### ADDENDUM #3

**PROJECT:** Farmington City  
Ivy Acres Park  
New Park Project

**DATE:** June 14, 2024

**ENGINEER:** Blu Line Designs

**LS103**

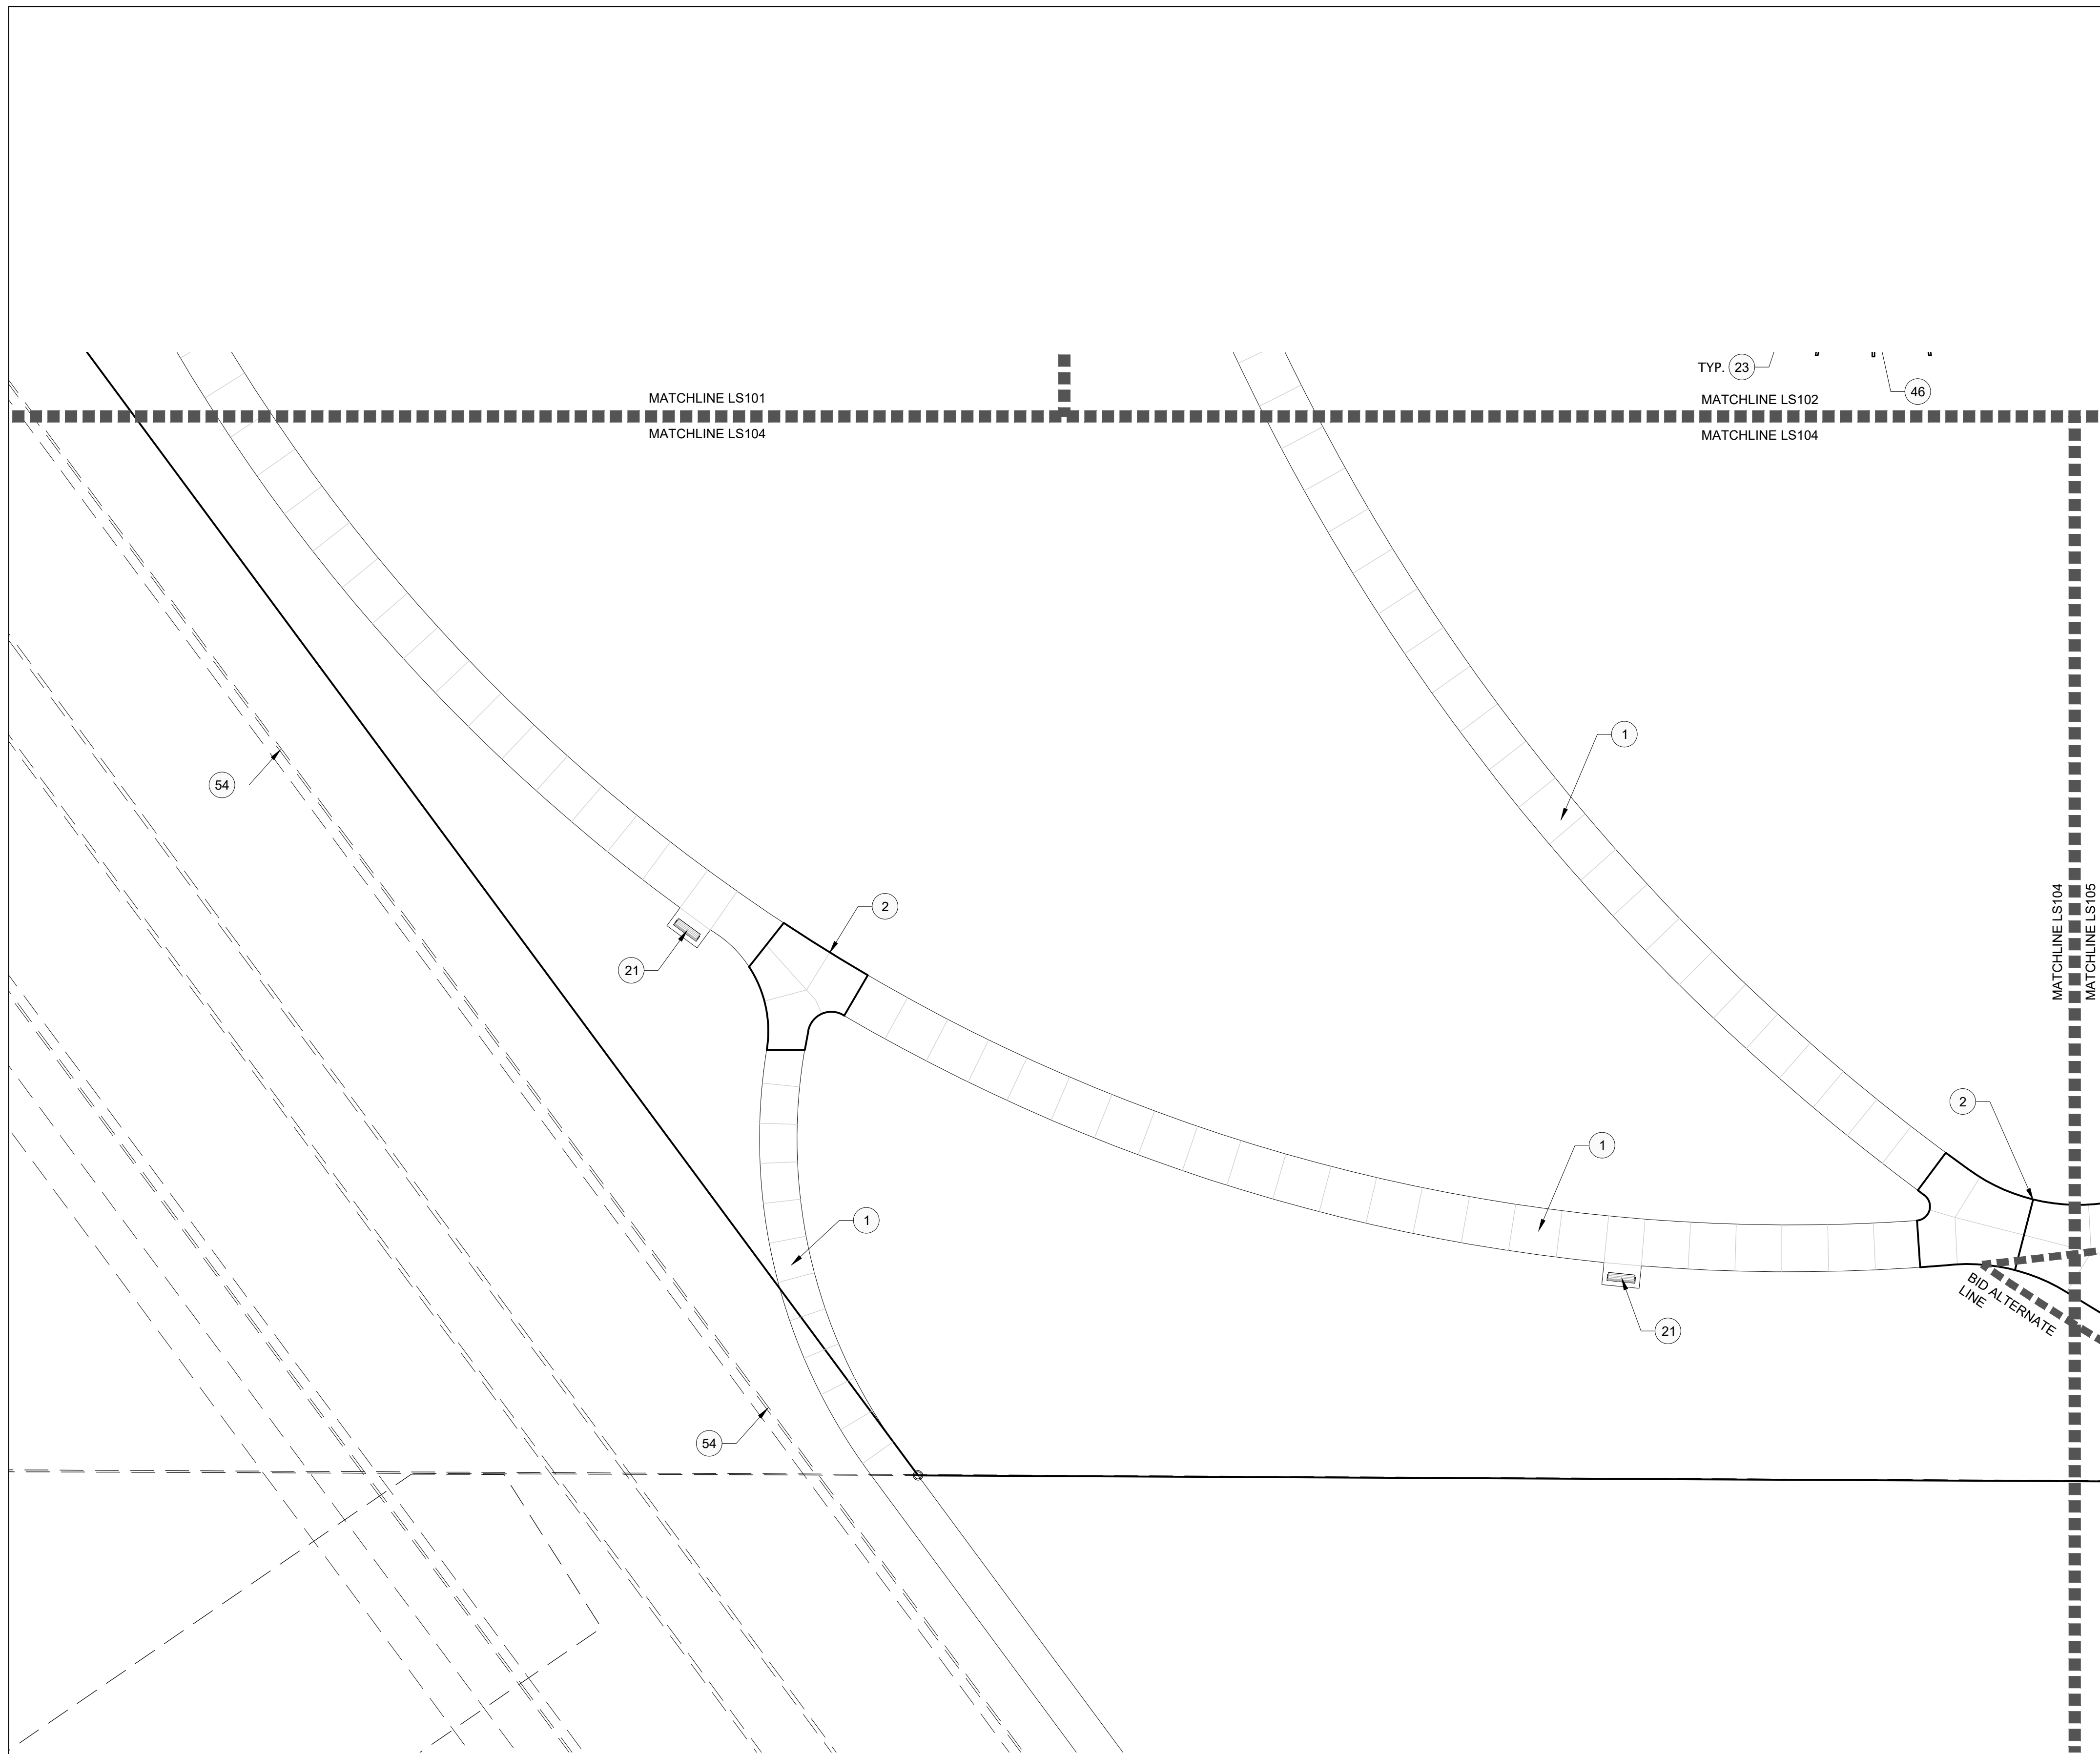
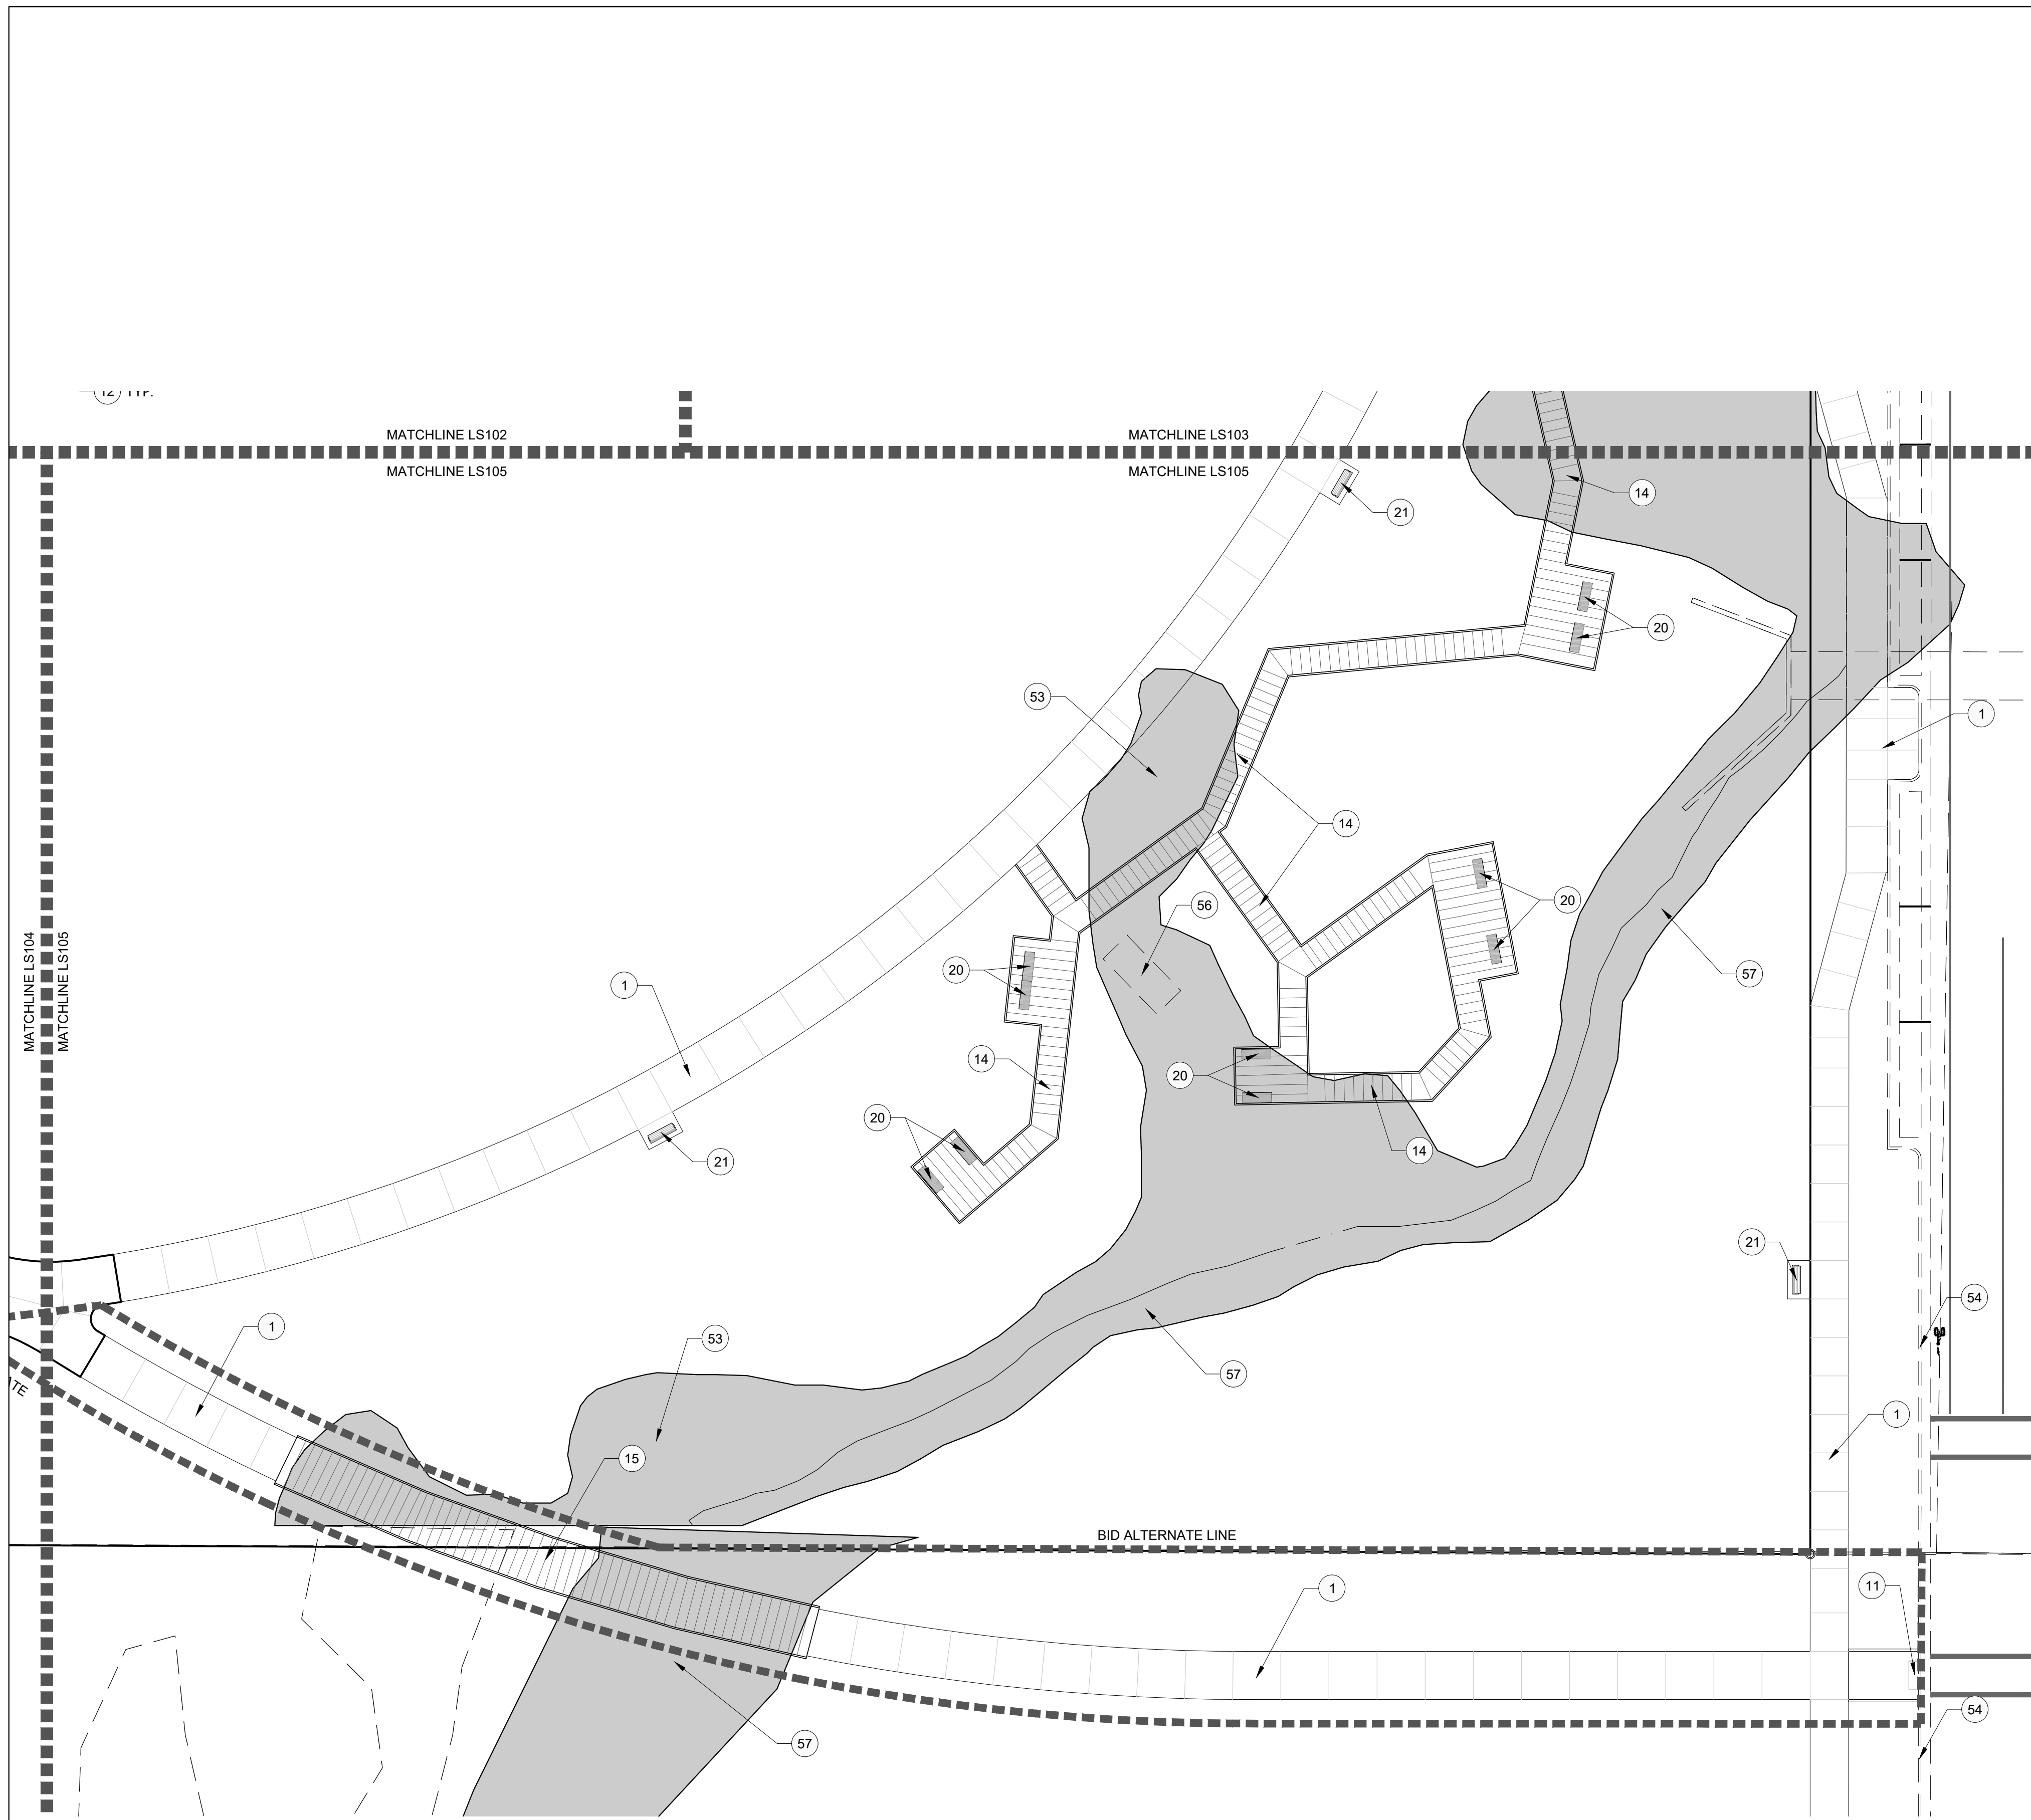
Item 3.1 **LS-101 thru LS-105:** Reference note schedule detail call outs are incorrect. Call outs and page numbers appear to be off. Please Review, revise and advise.

- Details that were being referenced to page LS-103 have now been corrected and will be shown correctly in sheets LS101-105 Schedule. See attached.

**1 FLOOR PLAN**  
 1/4" = 1'-0"

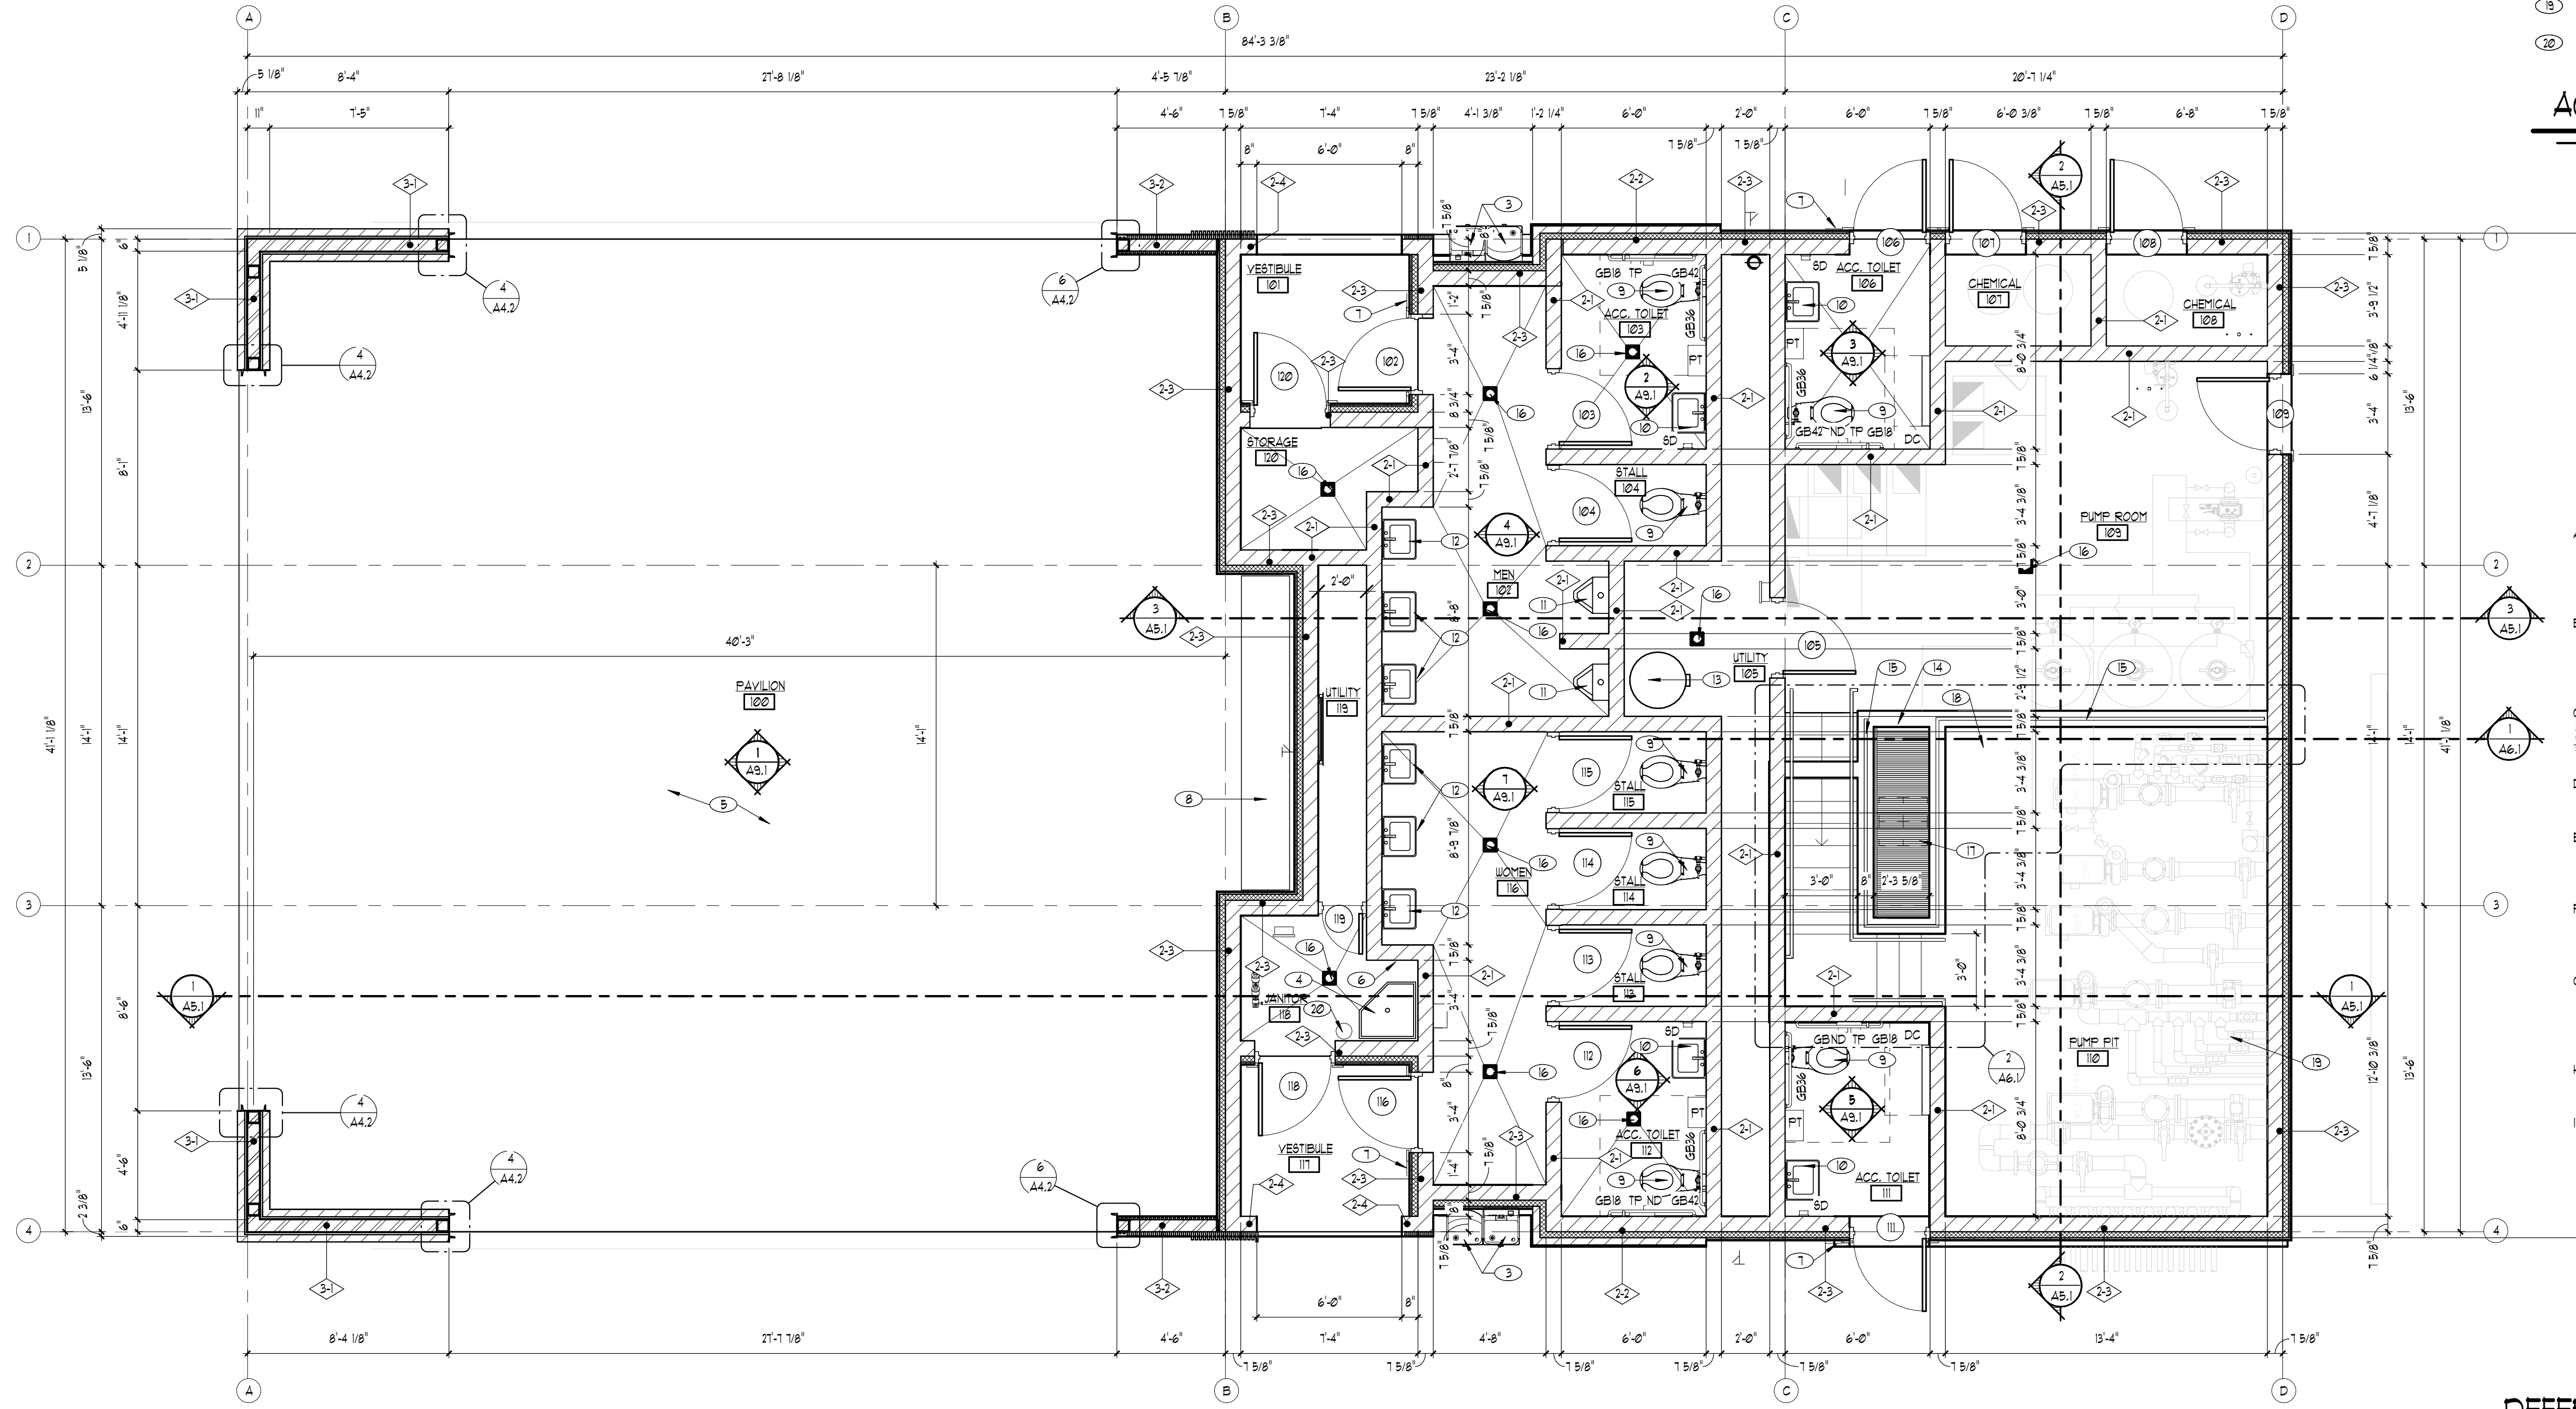
Item 3.7 Further Clarification to Addenda item 2.4  
ORIGINAL RESPONSE:

- **RESPONSE:** Farmington City will furnish and install Soap Dispensers. Contractor to furnish and install Toilet Paper Dispenser, Sanitary Napkin Disposal and Hand Dryer. Items are to be stainless steel. Paper Towel Dispensers will be removed from the project. See updated ACCESSORY ABBREVIATION legend on sheets A2.1 and A9.1. See revised specifications attached.
